RESEARCH REACTOR CENTER

REFERENCE: Docket No. 50-186
University of Missouri-Columbia Research Reactor
Amended Facility Operating License No. R-103

SUBJECT: Written communication as specified by 10 CFR 50.4(b)(1) regarding responses to the
"University of Missouri at Columbia - Request for Additional Information Regarding
the Proposed Technical Specifications for the Renewal of Facility Operating License
No. R-103 for the University of Missouri at Columbia Research Reactor (TAC No.
ME1580)," dated September 7, 2016

FIGURE 6.0
UNIVERSITY OF MISSOURI RESEARCH REACTOR (MURR)
ORGANIZATION

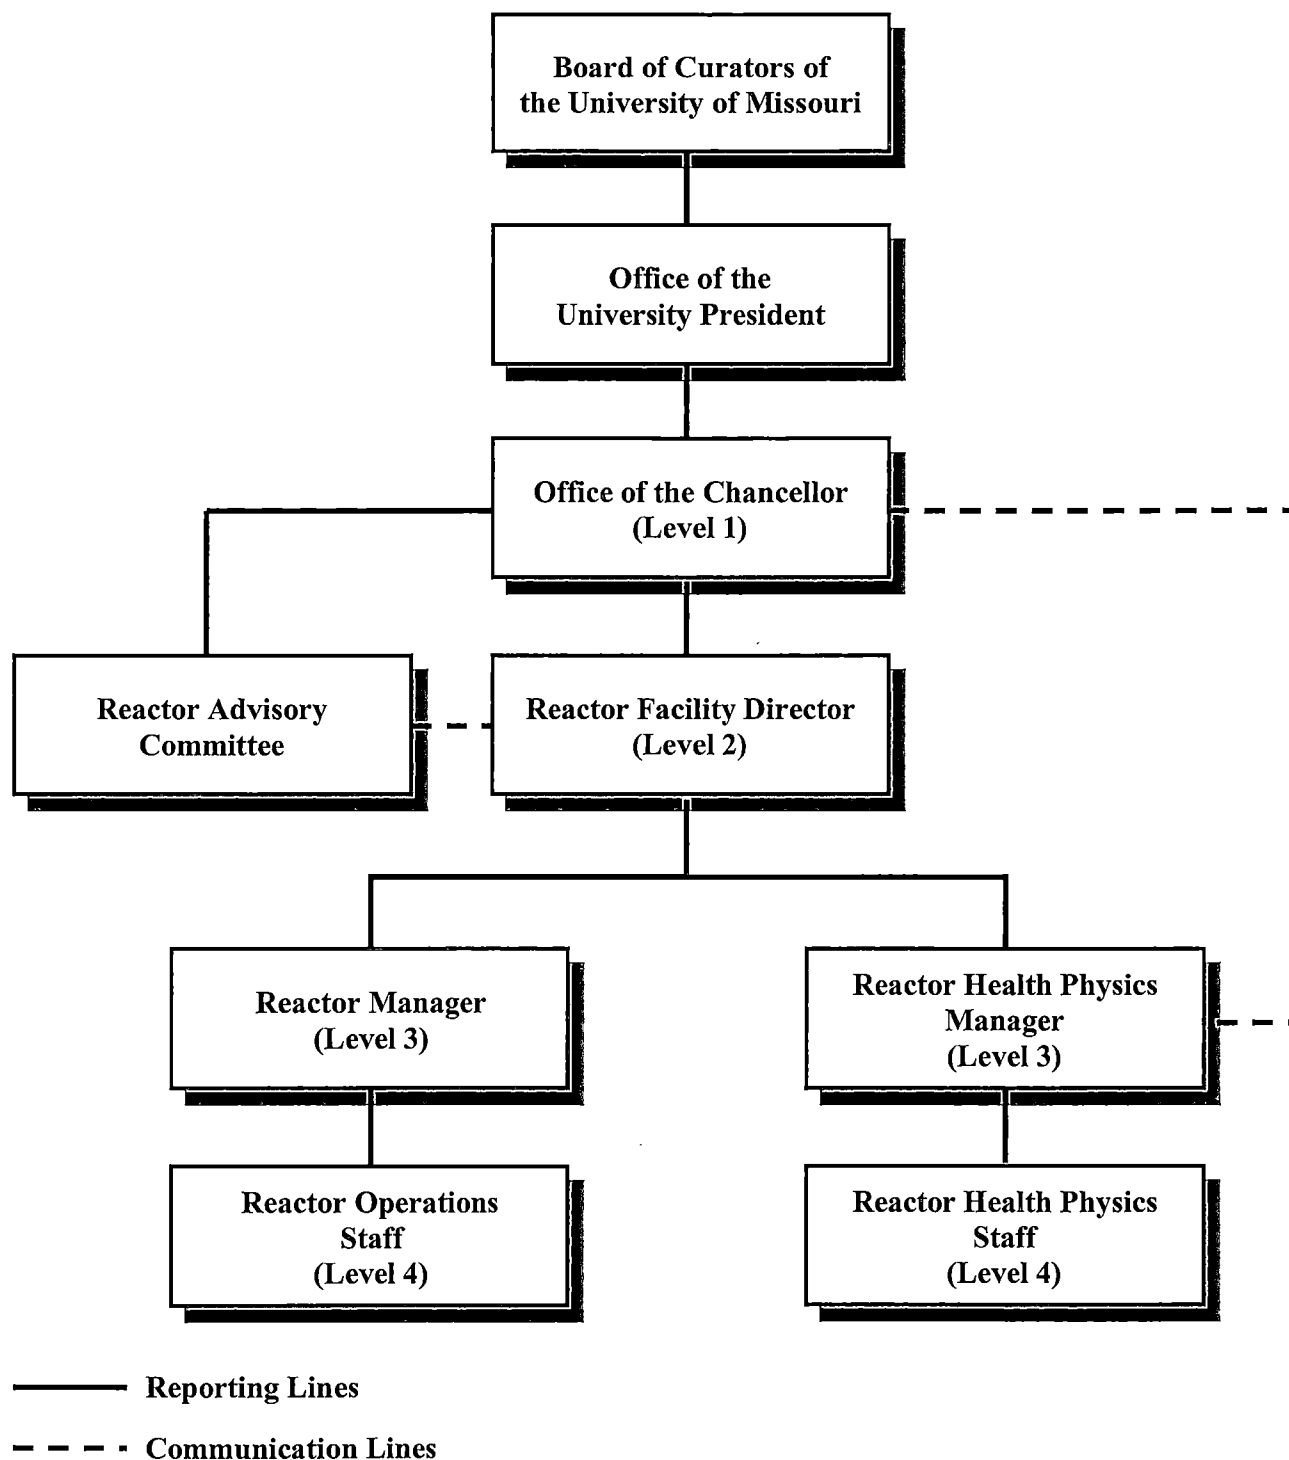
13. *Proposed TS 6.1, "Organization," Specification a, Figure 6.0, provides requirements for the MURR organization. However, the NRC staff finds that TS Figure 6.0 does not indicate the organization levels (e.g., Level 1, etc.).*

Revise proposed TS 6.1, Figure 6.0, to include the organizational levels, or justify why no change is needed.

The organizational levels have been added to Figure 6.0. Additionally, the Office of the Provost has been replaced by the Office of the Chancellor. As the land grant university and the largest public research university in Missouri, there has been an increased emphasis on the research being conducted by the University of Missouri. Recognizing this increased emphasis the University has elevated the Office of Research from reporting to the Office of the Provost to the Office of the Chancellor. As MURR continues to report to the Office of Research, which now reports directly to the Office of the Chancellor, it is appropriate to revise the organizational chart to reflect this new reporting relationship.
